Technical Memorandum

From:	BMT	To:	QRA, File
Date:	05 February 2020	CC:	
Subject:	BRCFS Model Amendment Pack (803.tcf)

1 Overview

Figure 2-1 Locations of Pipes (and Associated Model IDs) that have been amended

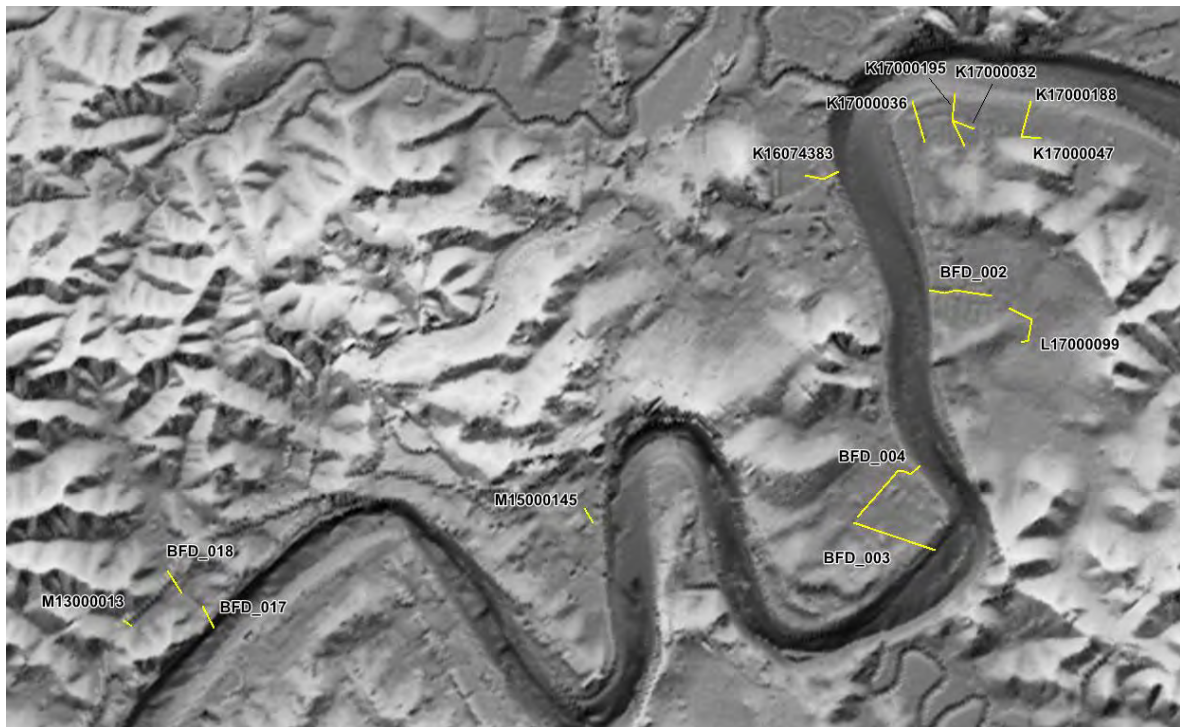
At the locations shown in Figure 2-1, the peak water surface level within a basin that is connected to the river via stormwater drains was found to be lower than that in the adjacent river for some design floods. Where this was occurring, it was apparent that the dimensions of the stormwater pipes connecting the basin to the river were not sufficiently large to allow basin and river peak water levels to equalise.

At these locations, the pipe dimensions have been upsized as part of this model amendment so that basin and river peak water levels equalise. The locations of upsized pipes or additional pipes are shown in Figure 2-1 and tabulated in Table 2-1.

In both the 1 in 50 and 1 in 100 AEPs, the peak levels in the Milton basin increase by up to 0.4m with an associated increase in flood extent. In the 1 in 200 AEP, the embankments are overtopped and the amended pipe dimensions have negligible effect on peak flood levels.

The additional stormwater pipe included in Brisbane CBD makes no difference to results in the 1 in 50 AEP (river levels too low to enter pipe) and 1 in 200 AEP (drowned out). In the 1 in 100 AEP the difference is localised to approximately two 30m grid cells with peak levels increasing by the order of 0.2m.

The New Farm area, near New Farm Park shows peak level increases from the 1 in 50 AEP through to the 1 in 500 AEP. The peak level increases are approximately 0.05m in the 1 in 100 AEP. The increases occur across the majority of the inundated areas for each respective event. The flood extents in New Farm are similar to previously modelled which is expected given the minor increases in flood level.

In the 1 in 50 AEP, there is additional inundation in the vicinity of Waterfront Park across approximately 30 modelled 30m grid cells. In the 1 in 100 AEP there are localised increases of up to 0.2m. For larger events there is no increase in peak flood levels.

Towards the north of the suburb of Hawthorne, backwater effects from the Brisbane River enter the suburb via the suburb of Bulimba. Amended pipe sizes in Bulimba have increased backwater inundation affecting (increasing) flood levels in Hawthorne by up to 0.4m in the 1 in 100 AEP event and 0.1m in the 1 in 200 AEP event. The area affected by increases is approximately 8ha. The flood extent increases by approximately 80 grid cells in the 1 in 100 AEP event and there is no noticeable change in flood extent in the 1 in 200 AEP.

No notable inundation to the suburb of Bulimba is predicted for events up to and including the 1 in 50 AEP. In the 1 in 100 AEP event, the suburb is inundated via backflow mechanisms and peak levels increase by up to 0.2m in affected areas due to amended pipe sizes. In the 1 in 200 AEP peak level increases are typically up to 0.1m across the inundated extent with larger increases of around 0.2m noted

in the vicinity of Johnston Park. There is no noticeable change in flood extent in the 1 in 100 AEP and a minor increase in flood extent in the 1 in 200 AEP (by around 30 grid cells).

Figure 2-2 Farm Dam shown in DEM Near Kholo

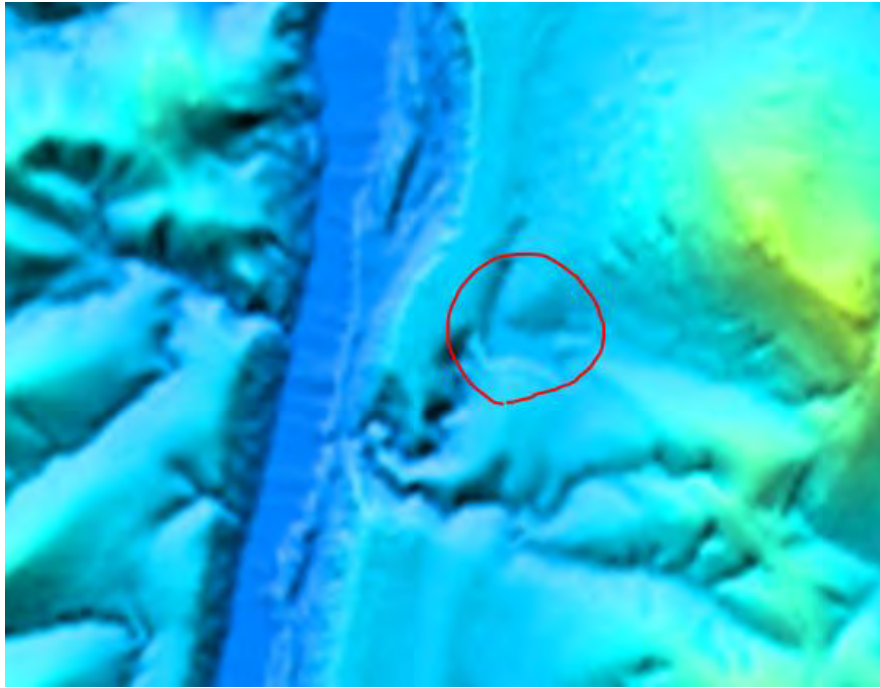
A lower peak flood level was identified across a small area of floodplain near Kholo compared to the peak level in the adjacent river. Upon inspection it was noted that a farm dam was present at this location (see area circled in Figure 2-2) and during the 1 in 100 AEP flood, water was beginning to spill over the dam wall from the river into the impounded dam lake. The water level in the dam did not reach the same peak level as the river level, which started to decrease before the dam was full.

Whilst the hydraulic effect is genuine, it is more meaningful to have a peak flood level that is consistent with that in the river at this location. Therefore, to resolve the issue, a breakline was used to form a gully which 'cuts through' the dam allowing water to enter the reservoir without having to overtop the dam wall. This allows water levels in the dam reservoir to rise and fall with that of the connected river (via a small tributary).

Figure 3-1 Modelled Water Levels at Centenary Bridge for 2011 Event (v605 vs v803)

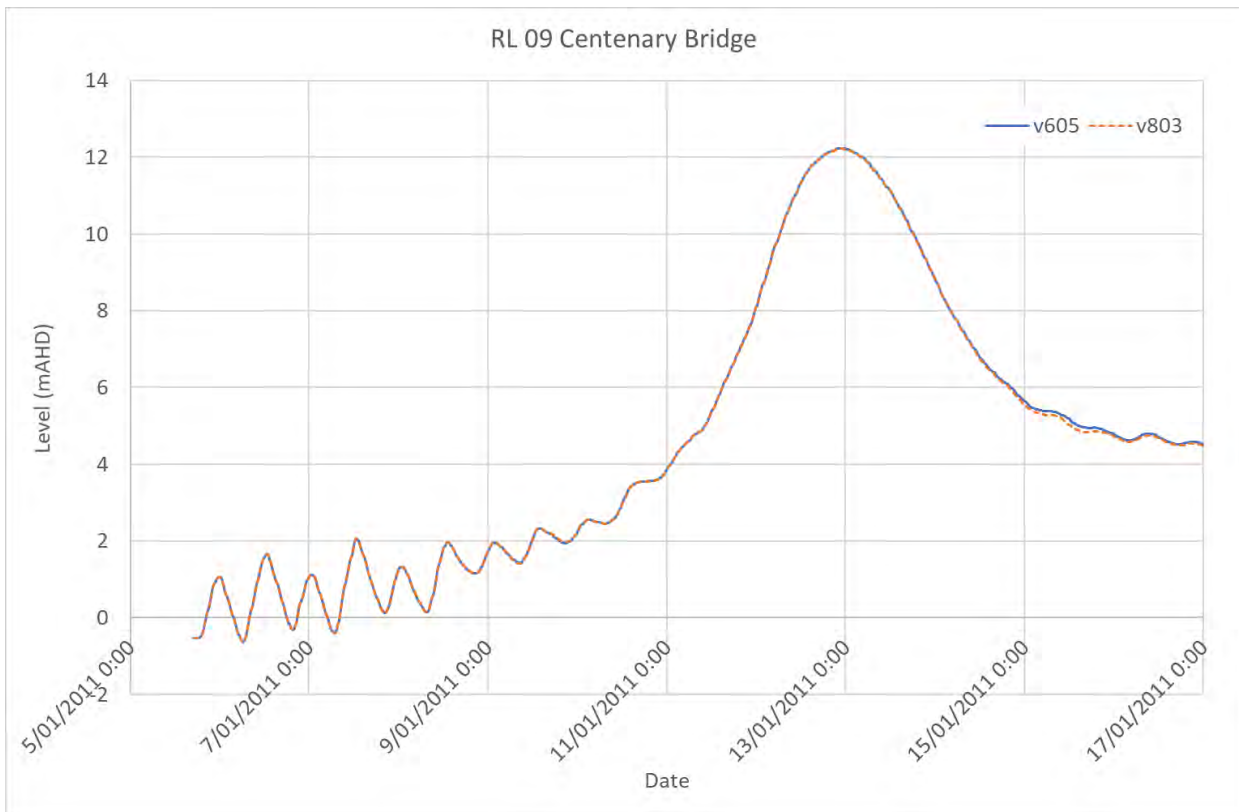
Figure 3-1 and Figure 3-2 present the modelled time series of water levels at Centenary Bridge and the City Gauge respectively for the 2011 event. These were two of the reporting locations used in the BRCFS on the lower Brisbane River. Each plot contains the results from simulating the 2011 event in the version 605 (original) model and version 803 (amended) model. As evident in the plots, the results are practically identical with no discernible change in the magnitude or timing of the flood.

Figure 3-3 Histogram of revised 2011 calibration results

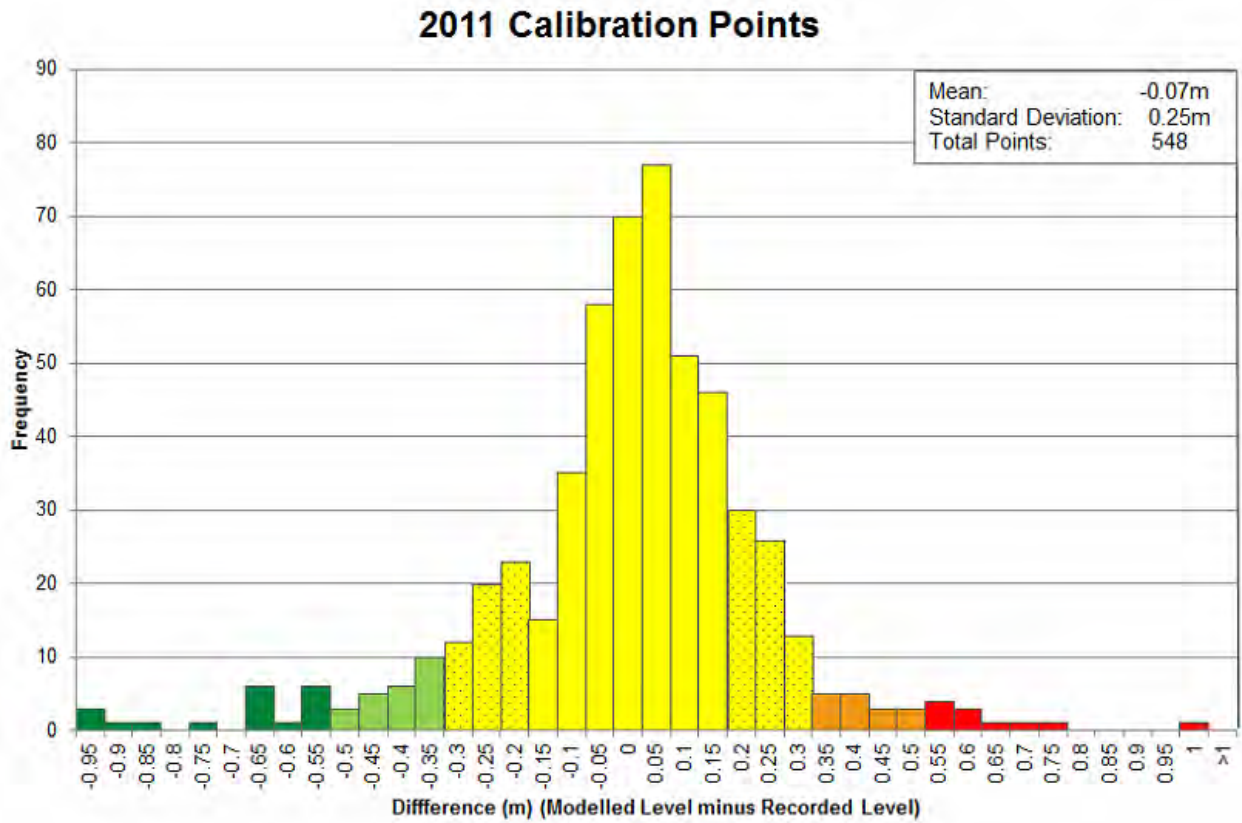
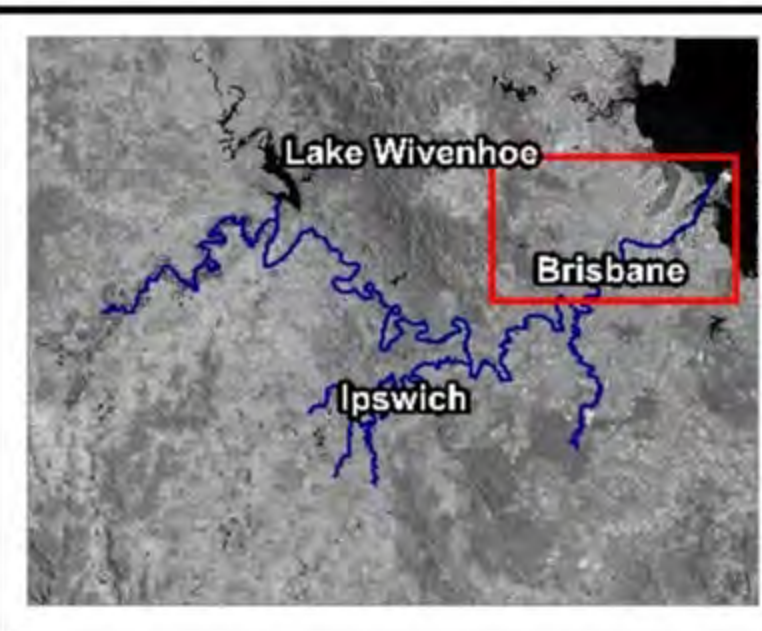
Figure 3-3 presents a histogram of differences at flood marks between modelled and recorded peak flood levels. A similar plot was included in Milestone Report 3 (MR3) of the BRCFS. The mean value is the same as in MR3 and the standard deviation has slightly decreased.

Drawing
3-1

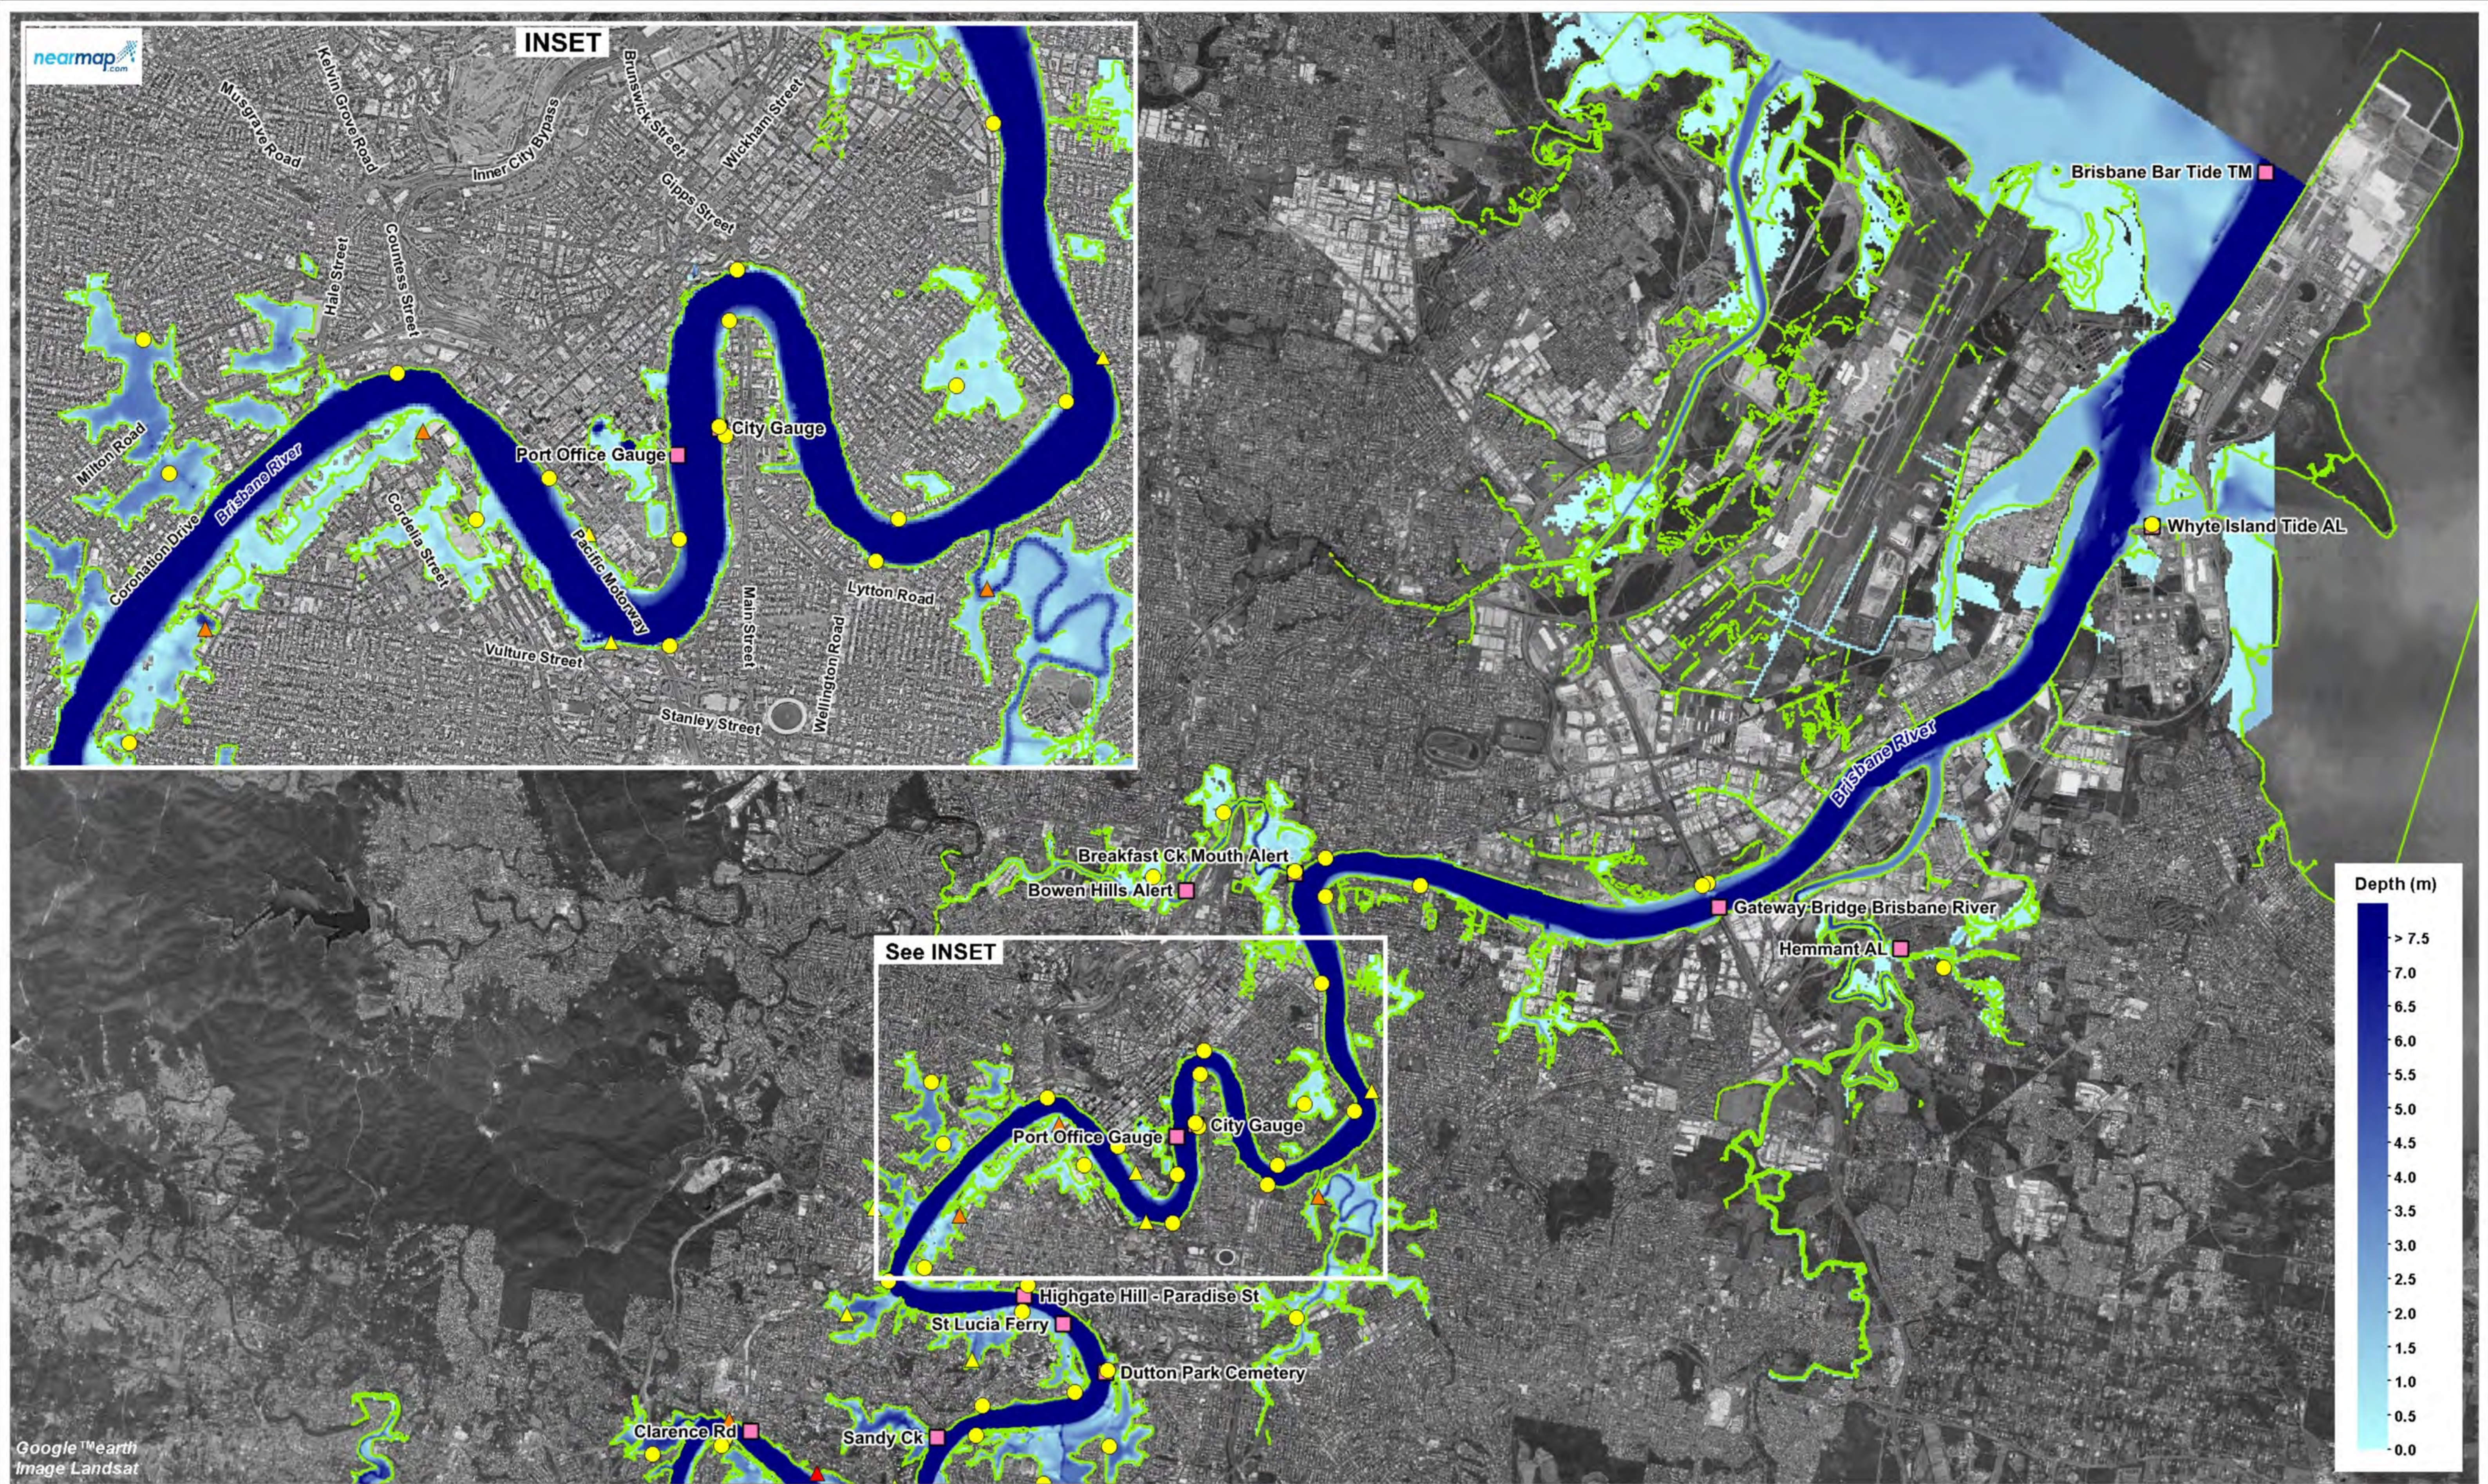
Drawing 3-1 presents a map showing the calibration performance to flood marks in the Brisbane inner city area (region E as mapped in the flood study). This region covers the area in which the majority of amendments have been made, including the upsized pipes into backwater areas.

As shown, at the majority of flood marks the calibration results are within 0.15m of the recorded peak levels. Of note are the calibration flood marks within the Milton basin which fall within the 0.15m tolerance indicating that the upsizing of the pipes in this area has improved the overall outcome in this localised area.
